HISTORIC DESIGN REVIEW BOARD

APPEAL APPLICATION

Date: May 29, 2007 Case #: H-04-114

Subject Property Address: 511 Paseo de Peralta

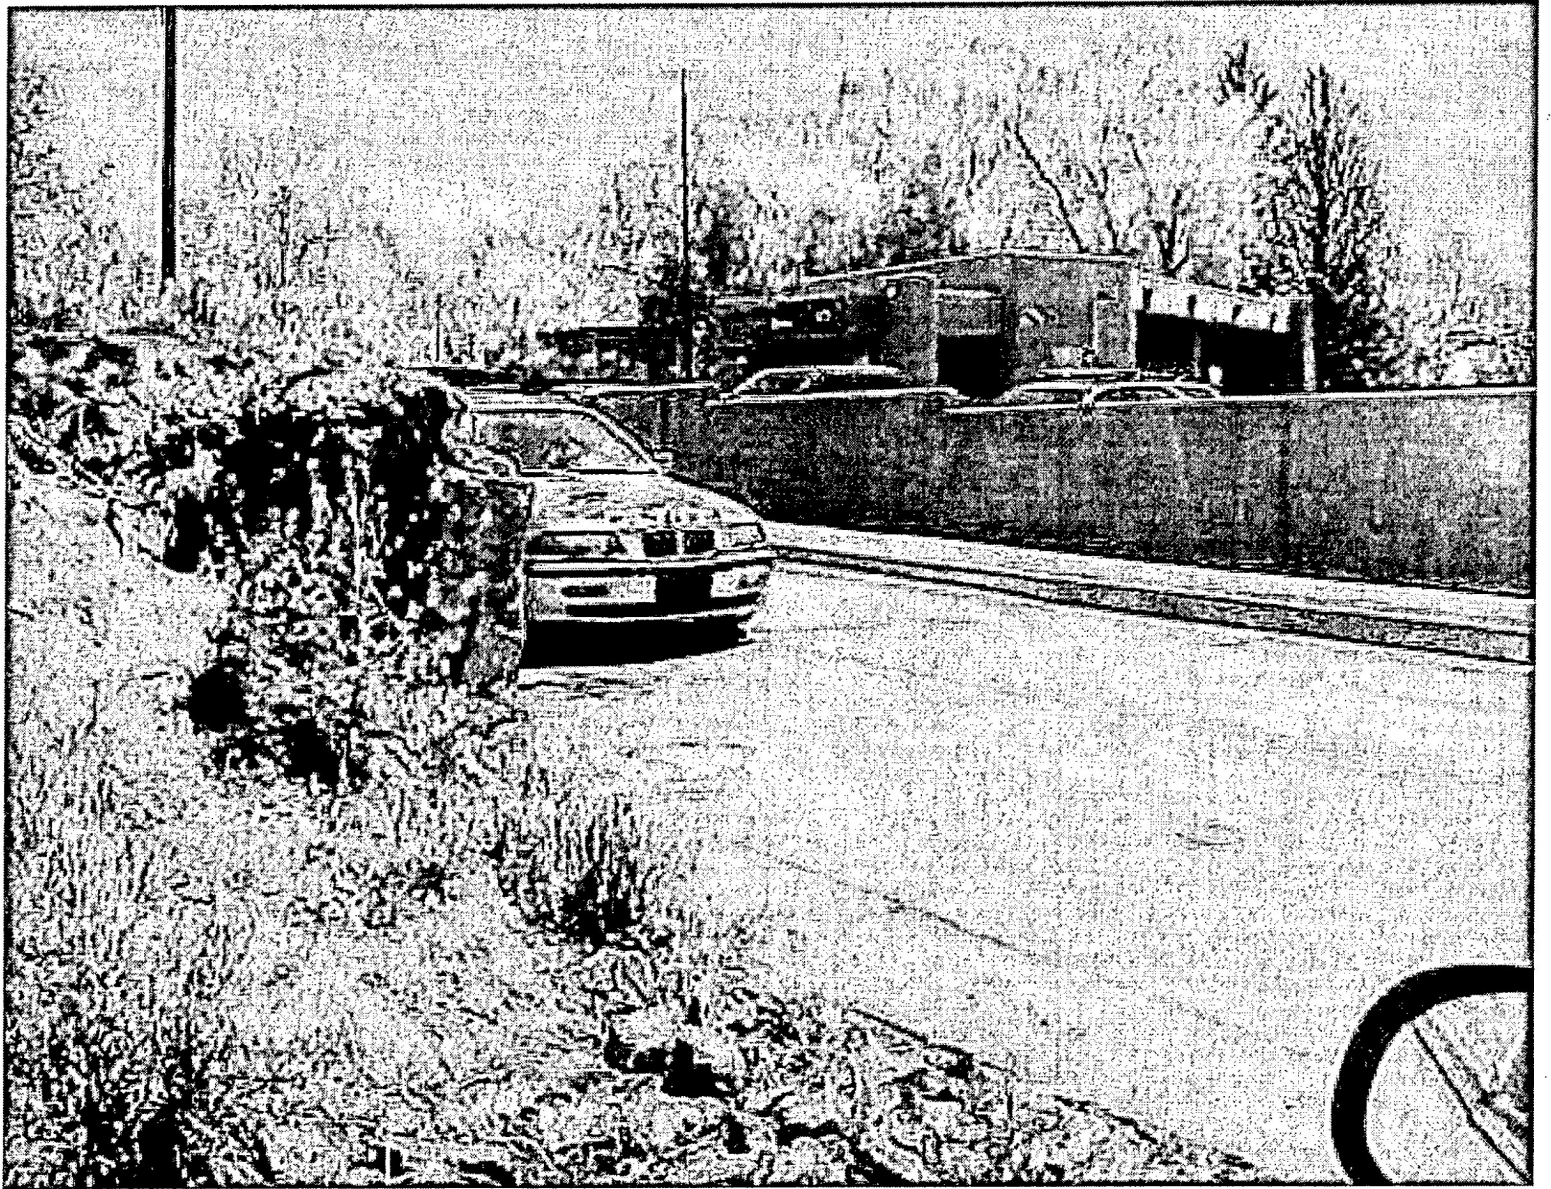
The developer has been asked by the PWD to design an access onto Paseo de Peralta with sufficient sight distance in order to accommodate a 25mph design speed (the posted speed limit on Paseo de Peralta). In order to provide adequate sight distance, the developer must remove a total of $\approx 103'$ of the wall measured from the south west corner of the subject property towards the east. This is base on requirements set forth in *A Policy on Geometric Design of Highways and Streets, 2004, 5th Edition* (Green Book), published by the American Association of State Highway and Transportation Officials. The Green Book is a nationally recognized policy used for the design of transportation facilities including urban arterials, collectors, and local roads. The guidance supplied by the Green Book is based on established practices and is supplemented by recent research.

The PWD appreciates the importance of maintaining historical features within the City of Santa Fe, where feasible, but in this case feels it important to ensure proper and safe egress and ingress from the Paseo Compound. The Transportation Research Board (who is supported by state transportation departments, the U.S. Department of Transportation, and other organizations and individuals interested in the development of transportation), through their National Cooperative Highway Research Program has made the following determination:

“Adequate sight distance for drivers at stop- or yield-controlled approaches to intersections has long been recognized as among the most important factors contributing to overall safety at unsignalized intersections. Estimates of the safety effectiveness of providing full intersection sight distance where it does not currently exist suggest that up to a 20% reduction in related crashes can be expected.”

proposed May 2007

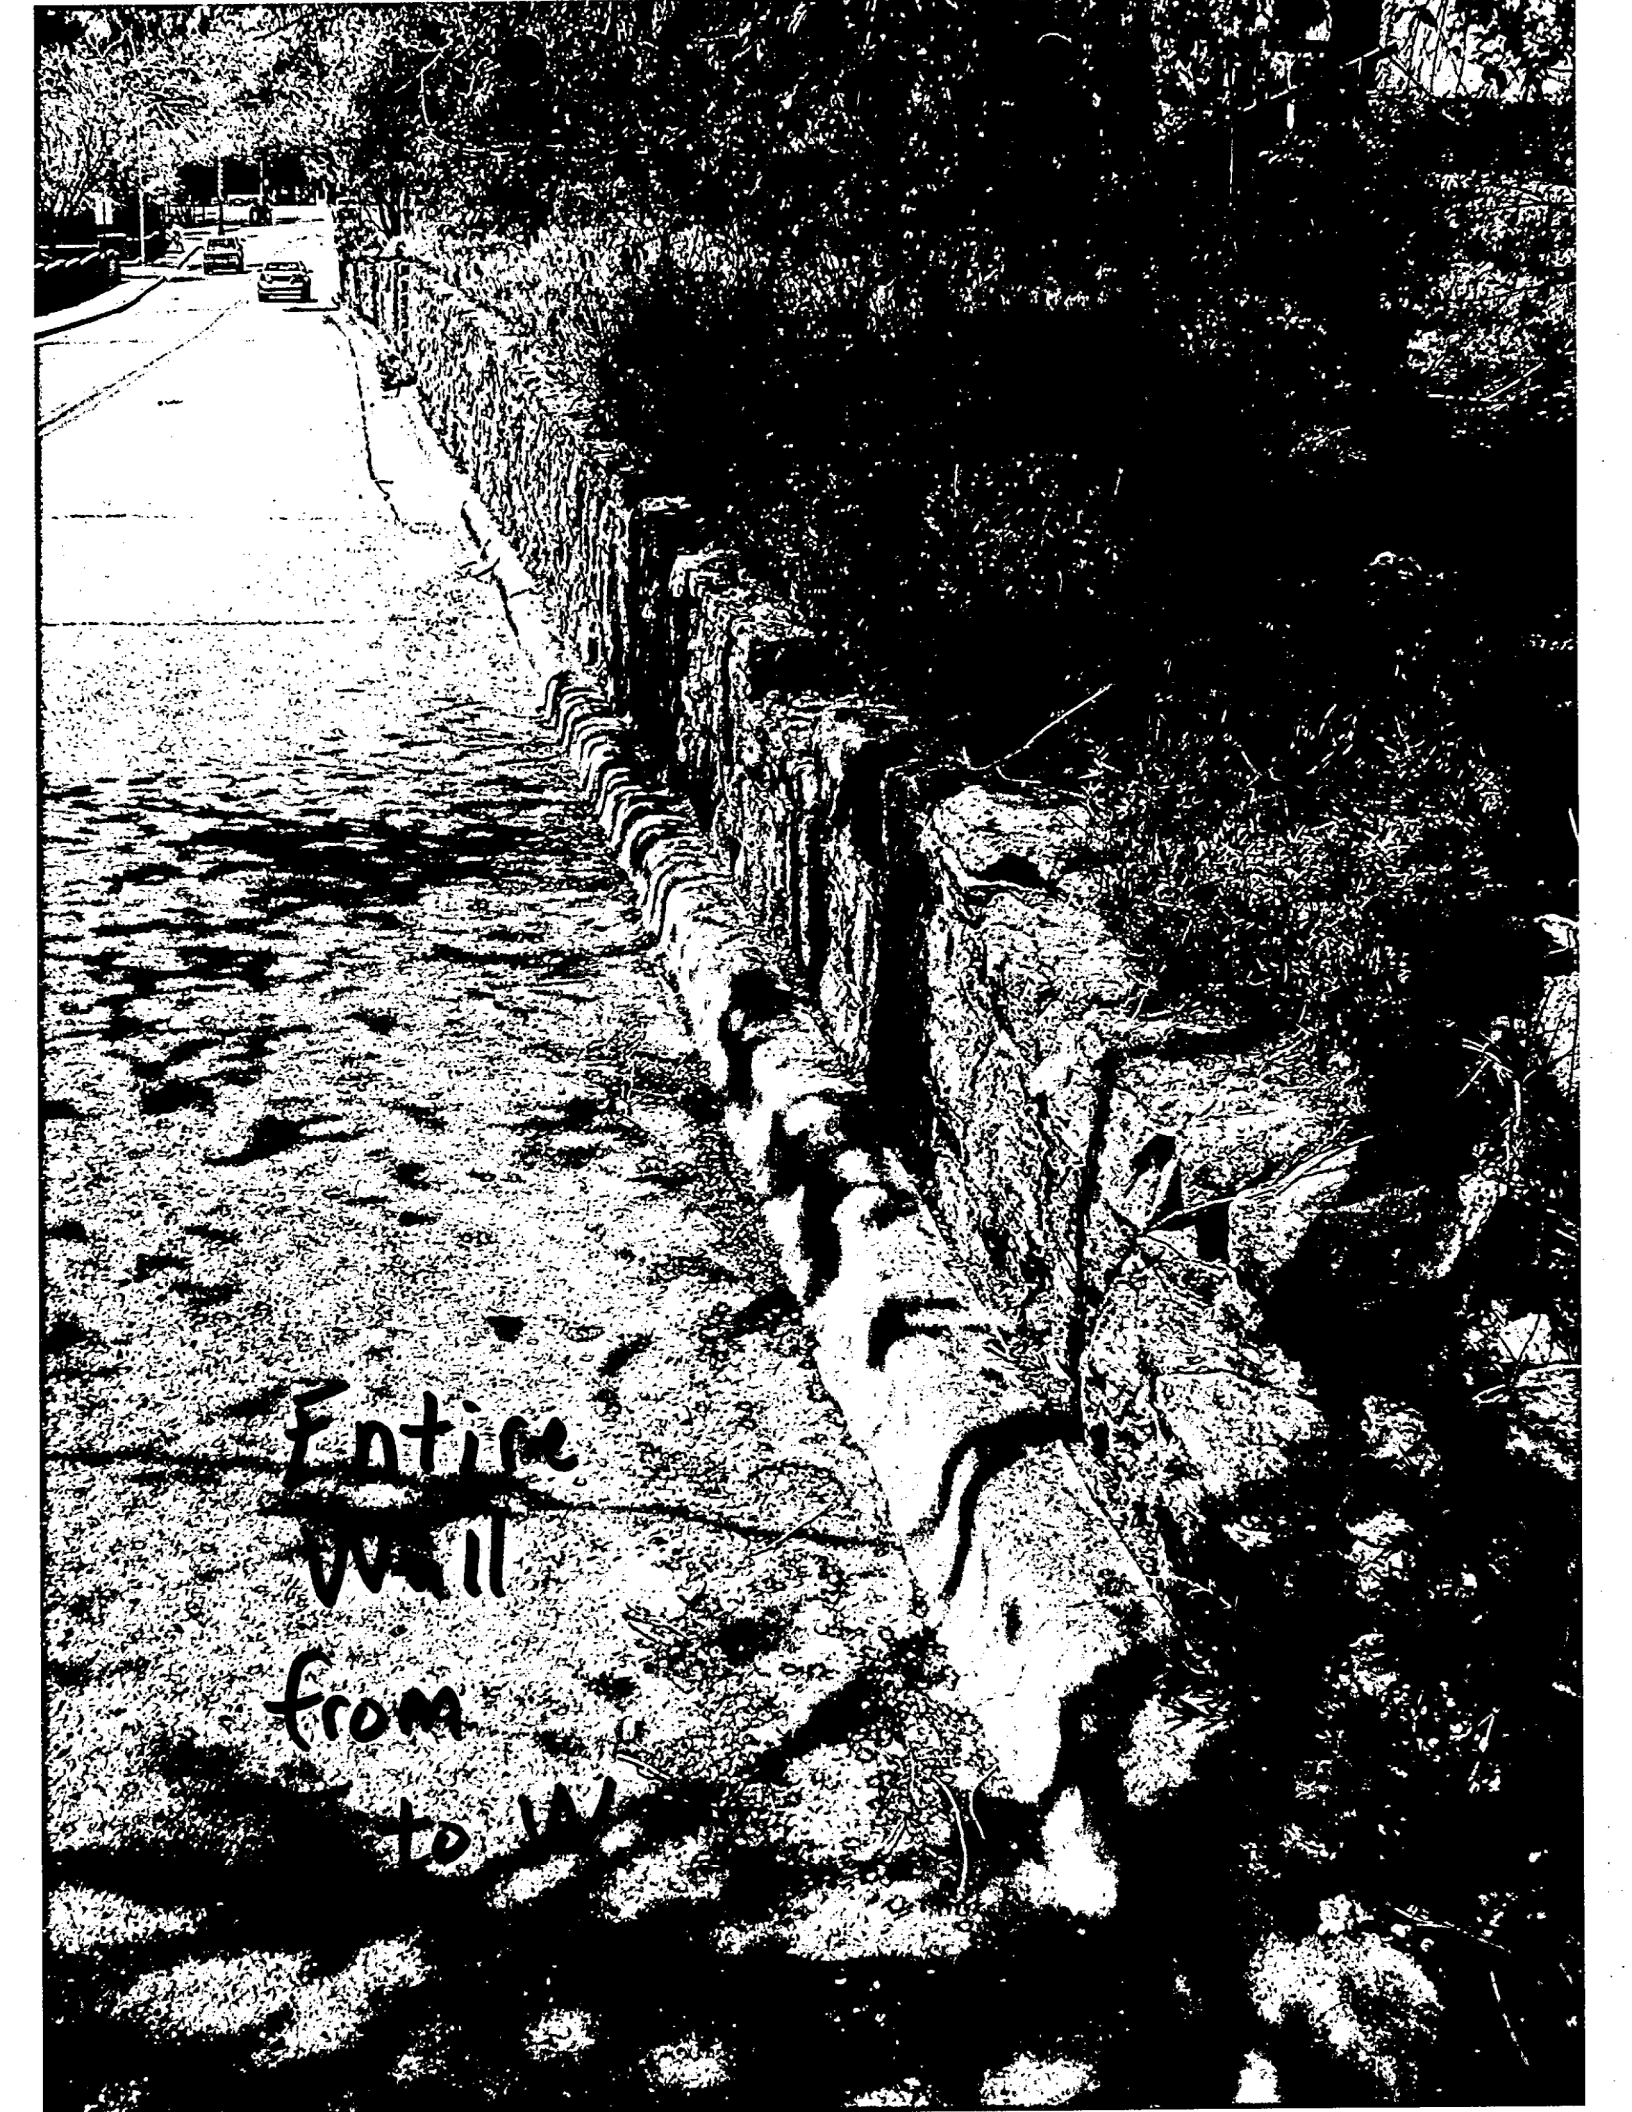
The request of Public Works is to demolish most of the historic stone wall in order to provide site safety triangle for exiting the property. That request was denied by historic in May 2007. This current request angles the existing wall and requires the wall to be lowered to 36 inches from the ground elevation at an angle lowering the wall height but allows the remaining wall to be left in tact. Thus maintaining the character of the streetscape for which the wall is an important part of.

Now, the applicant proposes to remove 72' of the streetscape wall in order to comply with AASHTO standards. The area behind the large triangle will need retaining and a stuccoed masonry wall is proposed along the diagonal line of the triangle. An exception to remove this historic material is required and the exception criteria responses are attached.
